Wybong Action Group ^{Incorporated}

Wybong Action Group Comment Regarding Table 1 Community Consultation Strategy

Wybong Action Group Comment Regarding the Mangoola Coal Construction Traffic Management Plan (Draft F & Final G)

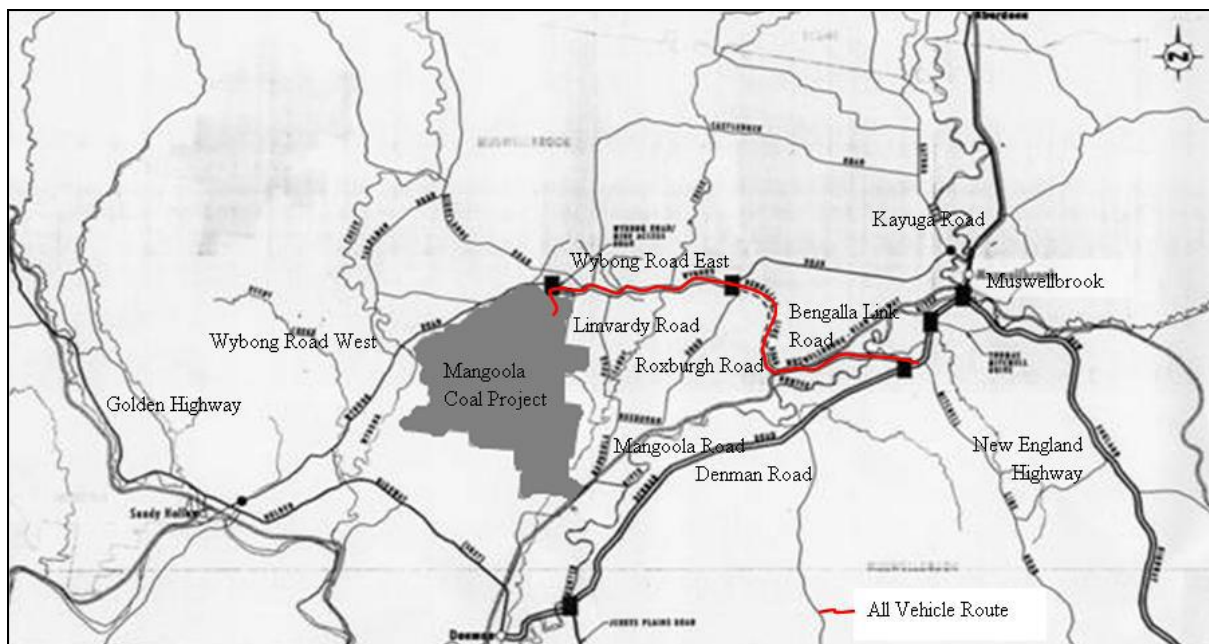
2.1 The Background Traffic figures of "528 vehicles per day and 45 heavy vehicles per day for the Mangoola Mine Northern Access Road-Bengalla Link Road section"¹ need to include an allowance, factor or prediction for increases in traffic resulting from the opening of the Bengalla Link Road extension to Wybong Road and the resulting new alignment of 'Wybong Road' with Thomas Mitchell

Drive/Denman Road and Golden Highway, Sandy Hollow and the conclusion of the Wybong Road Upgrade as this new alignment and upgraded travelling conditions are likely to attract a greater amount of background traffic to Wybong Road from 2010, including heavy vehicles from Bylong Valley Way, which will impact adversely on public safety and increased maintenance requirements (including on the non-upgraded Wybong Road West).

S2.7 Traffic Generation

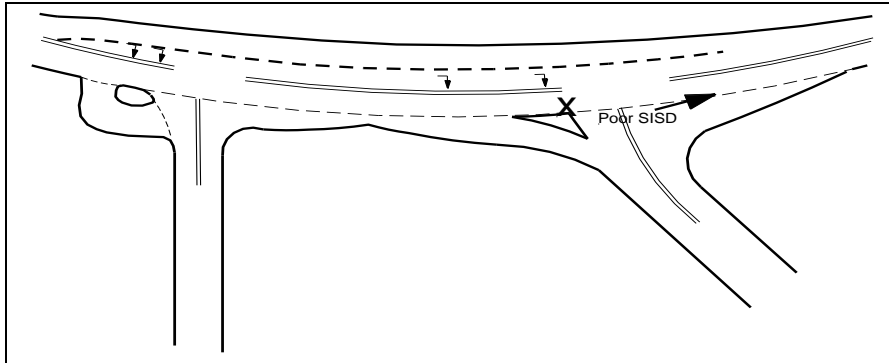
The type of Construction referred to as generating the truck movements listed is not defined as Early Works, Wybong Road East Upgrade or Mangoola Coal Mine construction related. The construction referred to needs to be defined.
